Re: 618 South Main Street, Ann Arbor, Michigan
Parcel Identification Number ("PIN"): 09-09-29-415-015

APPLICATION FOR VARIANCE - BUILDING BOARD OF APPEALS

618 SOUTH MAIN
DUPLIX UNIT STAIR VARIANCE
NOT TO SCALE

Re: 618 S. Main Street Apartments (6) Duplex Stairways

DWELLING UNIT PLAN - CURRENT

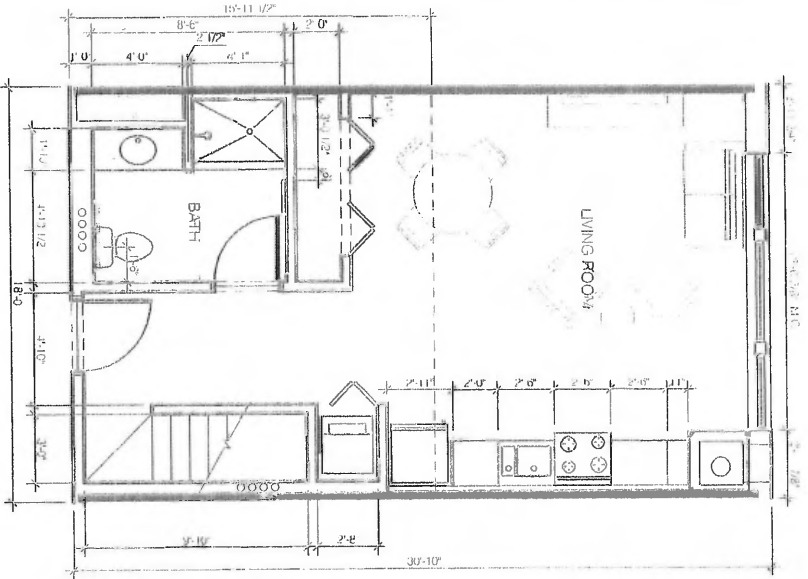
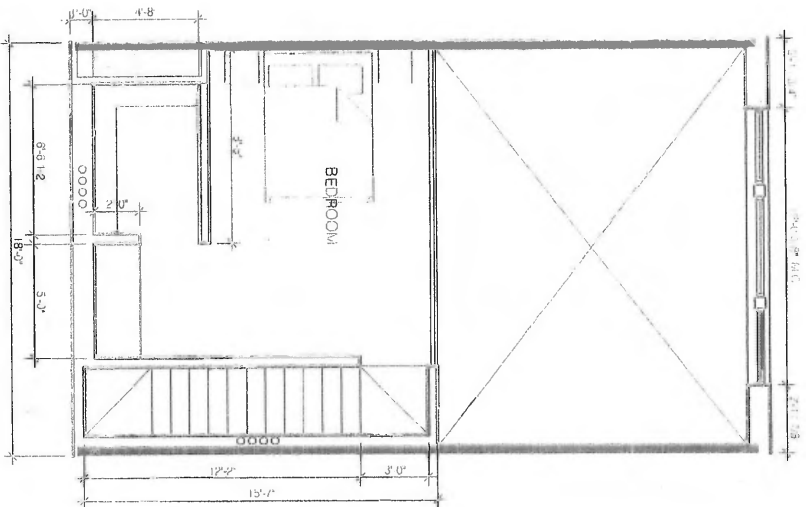
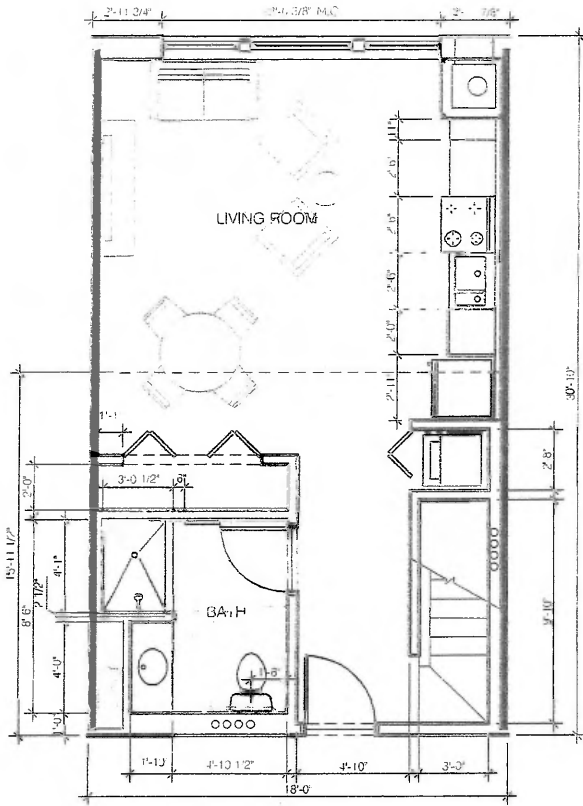
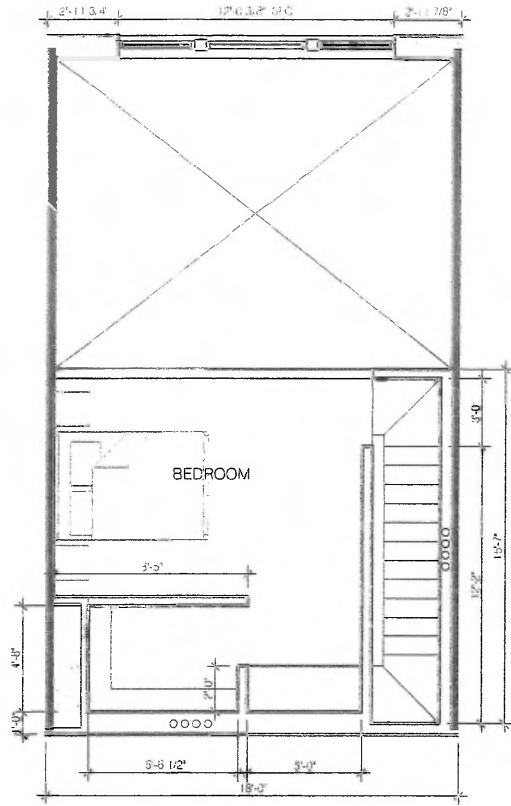
MODIFICATION OF EXISTING CONNECTING STAIR WITHIN 6 2-STORY APARTMENT UNITS IN AN EXISTING MULTI-FAMILY BUILDING SO STAIR TREADS MEET MINIMUM WIDTH REQUIREMENTS

1. Section 1009.4.2 (5) of the MBC requires a minimum tread depth of 6" at the narrow part of the winder tread. The current stair design depth is 0". In order to achieve the correct winder tread depth the stairway would need to be narrowed by 6" at the inside part of the stairway. The stair would then be 30" wide instead of the required 36" specified in section 1009.1. The proposed design is attached for your review.

Section 1009.9 allows a spiral stairway to serve a space not more than 250 square feet and the width of the stairway can be 26". These loft spaces are well under that limit and I would submit that these proposed stairs could be considered a "hybrid" due to the winders at the top and bottom. I would recommend that the board grant a variance to allow these stairways (6 total) to be 30" wide to accommodate the minimum tread depth. The 3 remaining stairways will need the modification as well due to the fact that the space is already built out and the required stair geometry will not work in the existing stairwells.
